Subject: Supplemental Comments LTMMMP

**Citizen Action Supplemental Comments to Sandia National
Laboratories (SNL) Long-Term Monitoring and Maintenance Plan
(LTMMP) for the Mixed Waste Landfill (MWL), an Unlined
Radioactive and Hazardous Waste Dump
February 11, 2013**

Figure 2 Mixed Waste Landfill Monitoring Well Locations

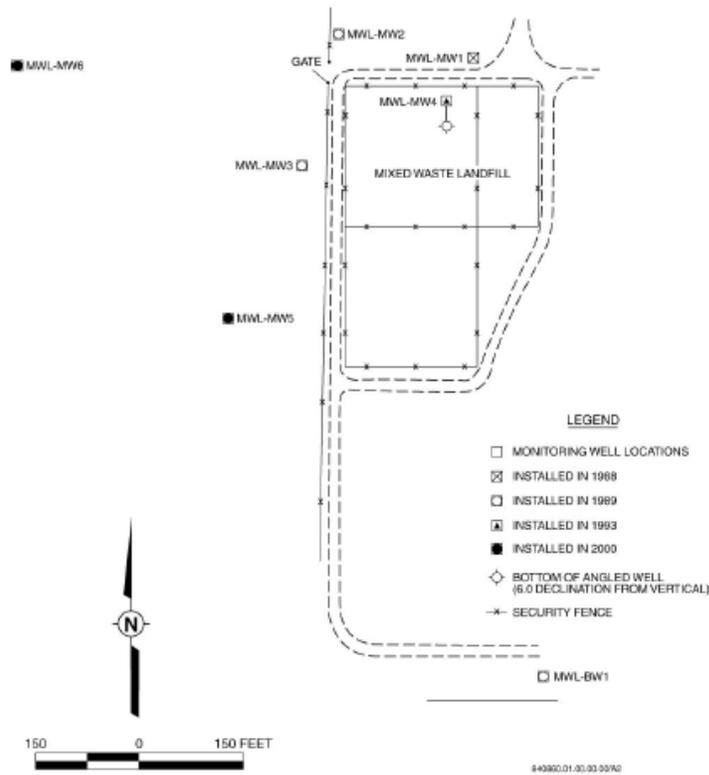
- h. There is a failure to provide an adequate number of wells at appropriate locations to monitor both the layer of fine-grained sediments at the water table and the deeper strata in the uppermost aquifer. There are no monitoring wells installed at the “point of compliance” given the flow directions that are described as to the southwest or the northwest as required by RCRA 40 CFR §264.95;

Groundwater flow direction. The only monitoring well in the vicinity of the MWL that is installed in the ARG uppermost aquifer is MWL-MW6. As shown on Figure 2, well MW6 is located 500 feet west of the western boundary of the MWL. Compliance with § 264.98(e) requires the installation of an appropriate number of monitoring wells in the uppermost aquifer:
